RE: **6615 Papagayo NW, SAD 228**
Pad Certification for lot 5 Block 5 Unit 18
Engineers Stamp Date 9/6/16 (D10D003K5)
Certification Date 10/11/16

**RE: Revised Grading Plan
6615 Papagayo
Lot 5, Block 5 volcano cliffs unit 18-SAD228
Drainage file D10-D003K5**

ENGINEER'S SEAL  8/24/16 DAVID SOULE P.E. #14522	LOT 5, BLOCK 5, UNIT 18 VOLCANO CLIFFS SUBDIVISION	DRAWN BY JDG
	GRADING AND DRAINAGE PLAN	DATE 08-09-2016
 Rio Grande Engineering 1606 CENTRAL AVENUE SE SUITE 201 ALBUQUERQUE, NM 87106 (505) 872-0999		SHEET # 1 OF 1
		JOB #

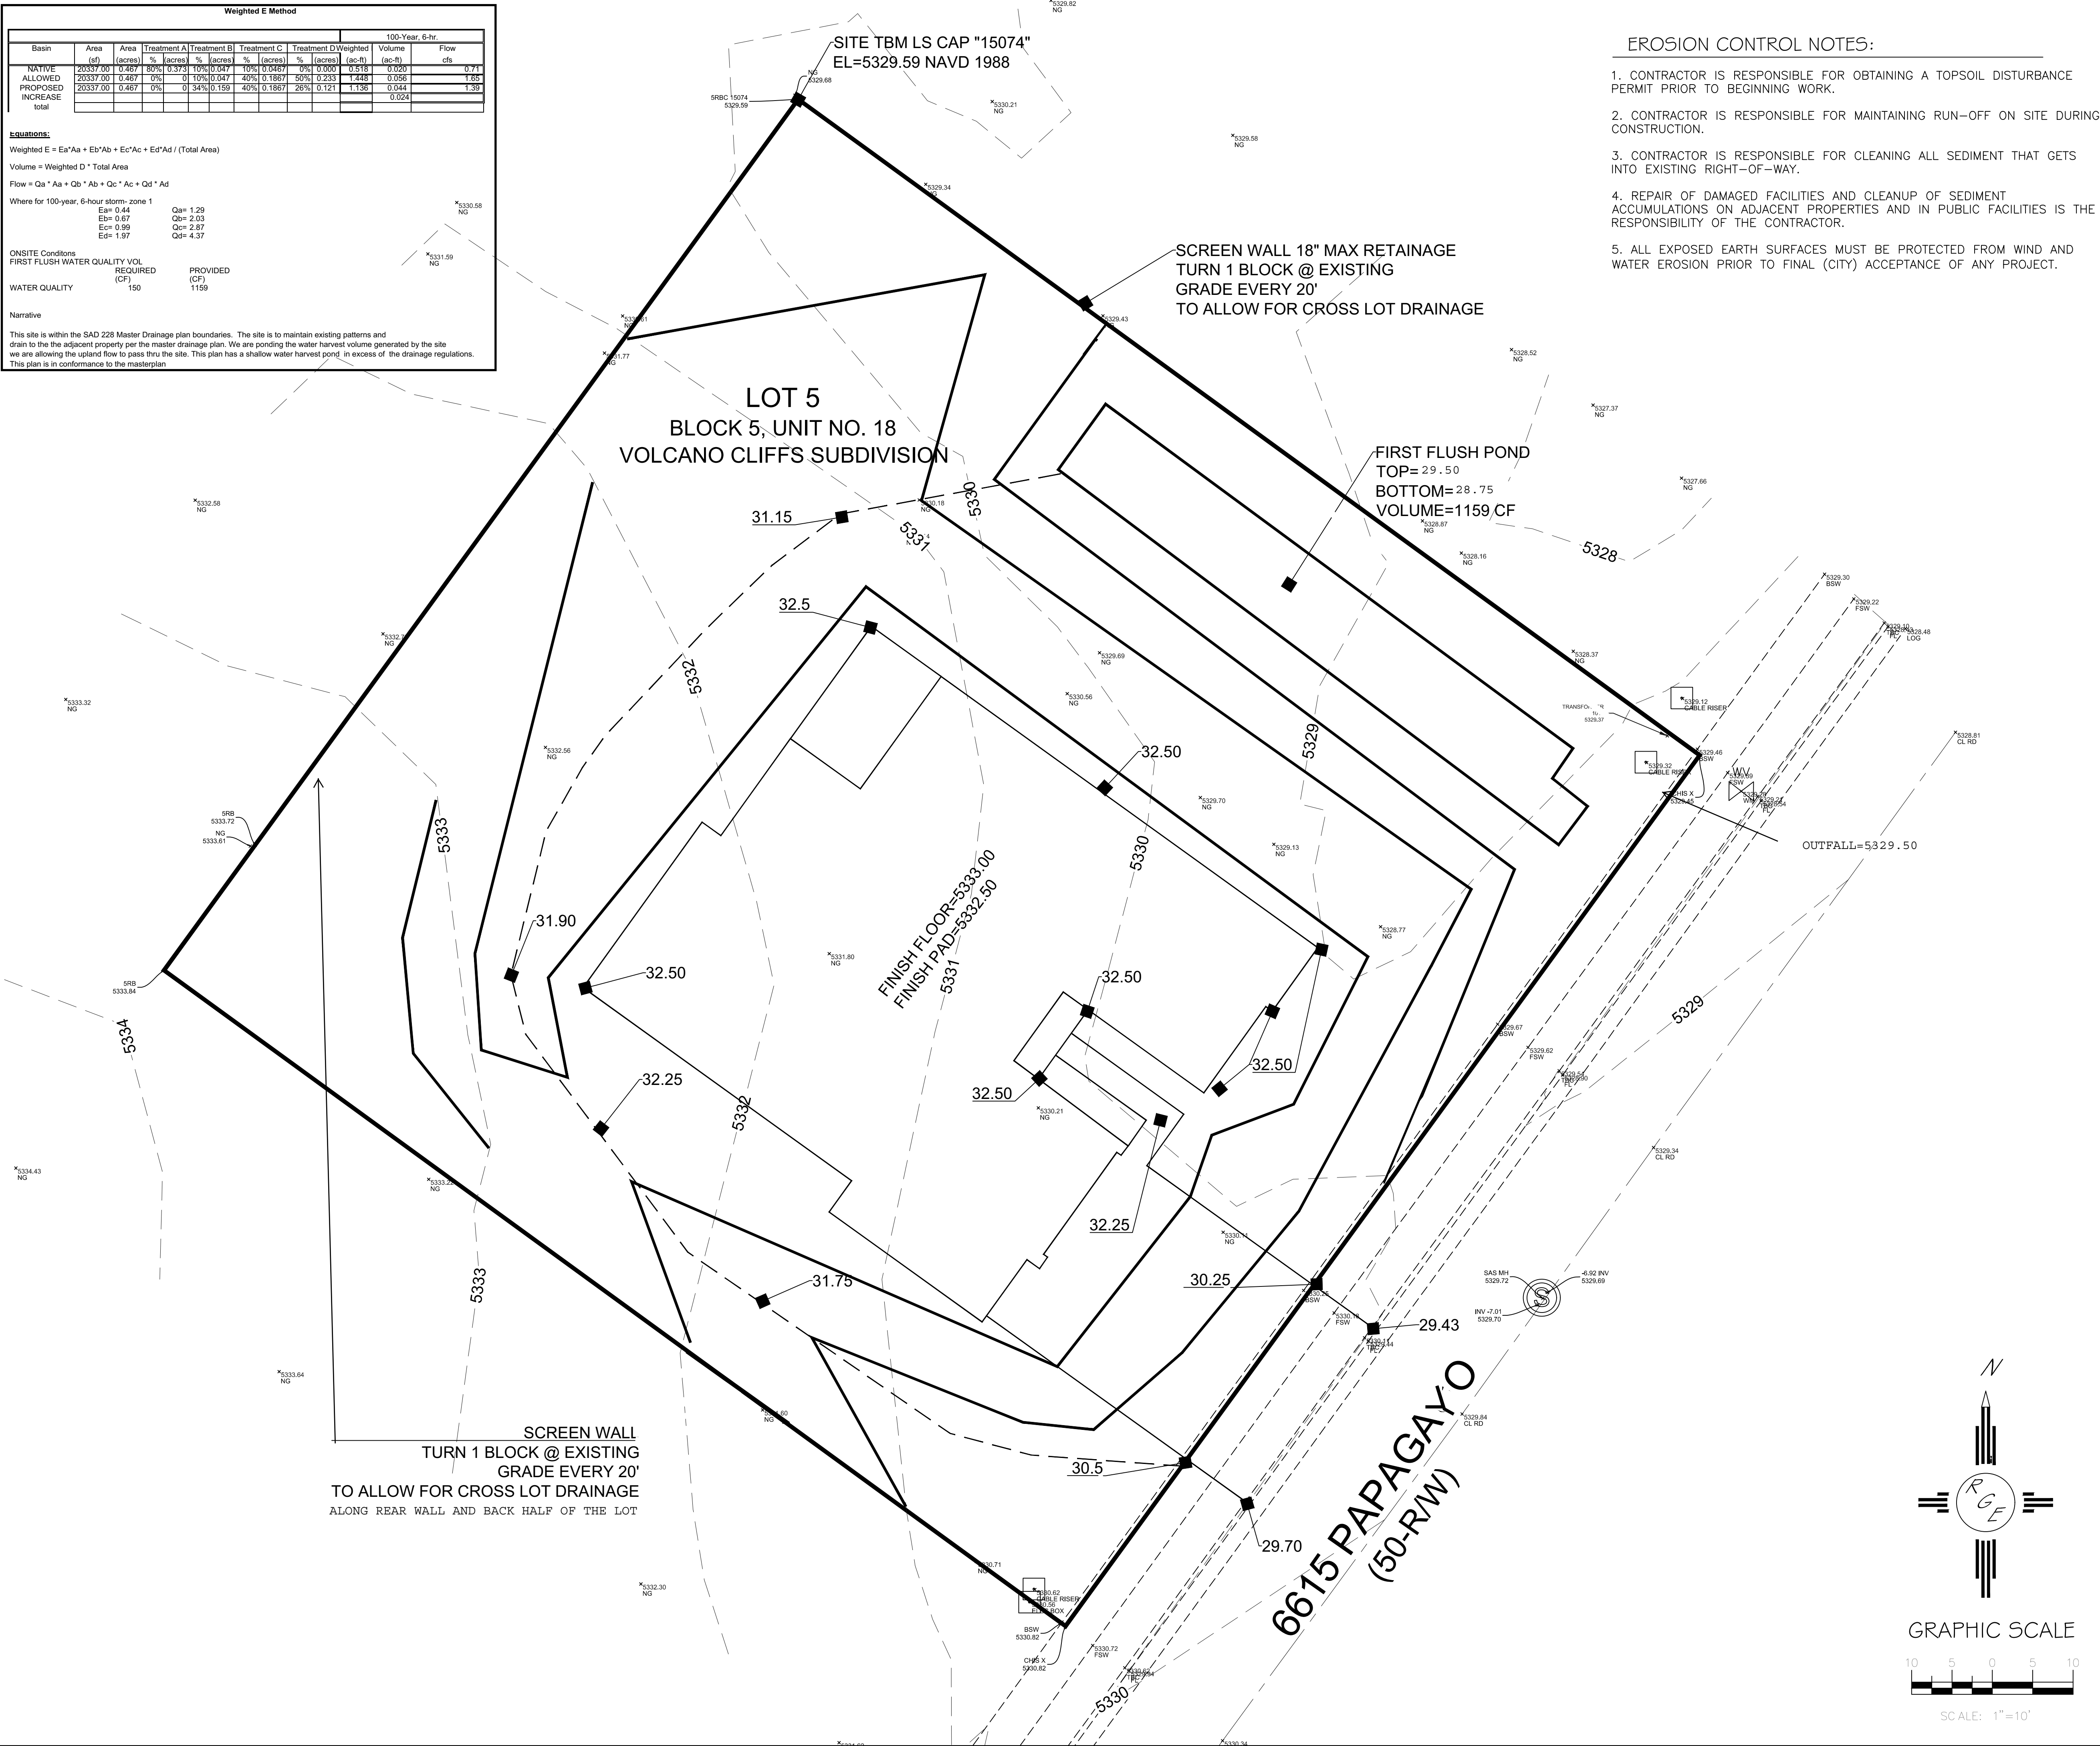
Based upon the information provided in your submittal received 10/11/2016, the above referenced Certification for 6615 Papagayo Rd. NW is acceptable for building permit.
